XF 宁波翔沣电气有限公司 NINGBO XF ELECTRONIC CO.,LTD					Name		Cover	
					DrawingNo		282108C	
					Material		PP+GF15	
Design	Lai	2025.11	Revision	01	Color		Nature	
Proofread	Yang	2025.11			Weight Kg			
Approval	Zhang	2025.11	Scale	1.5:1		Pages

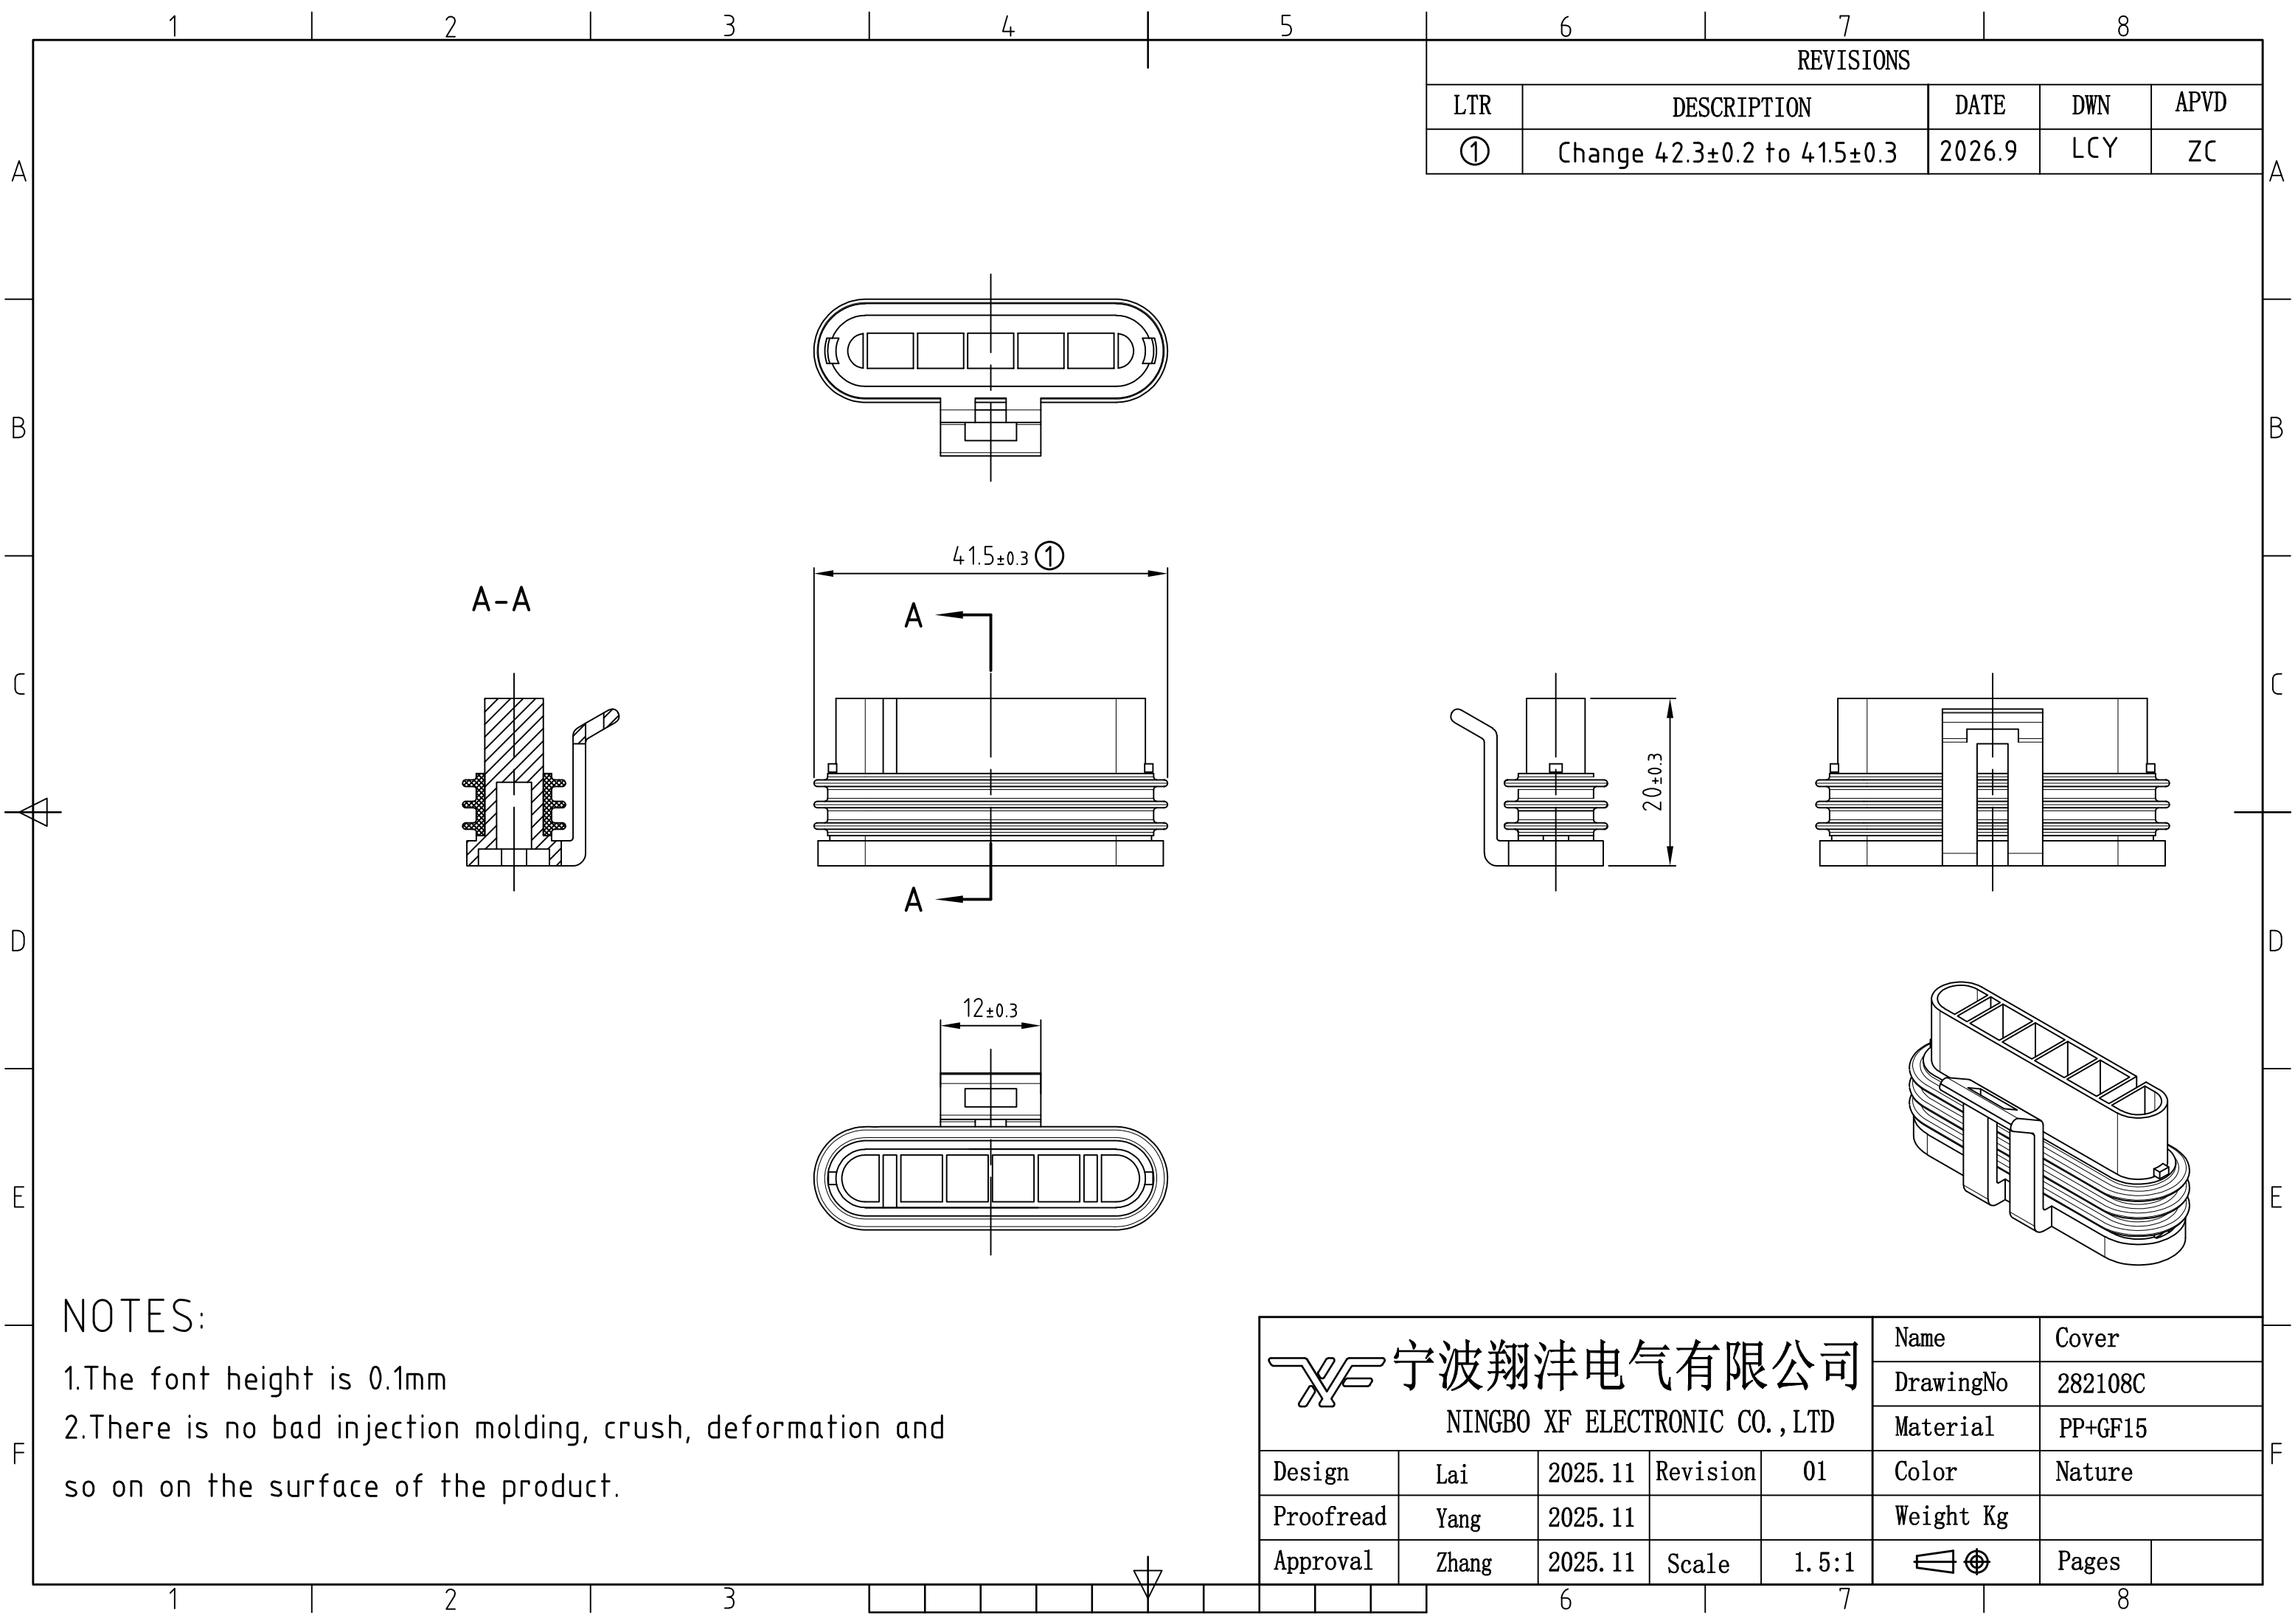
REVISIONS				
LTR	DESCRIPTION	DATE	DWN	APVD
①	Change 42.3±0.2 to 41.5±0.3	2026.9	LCY	ZC
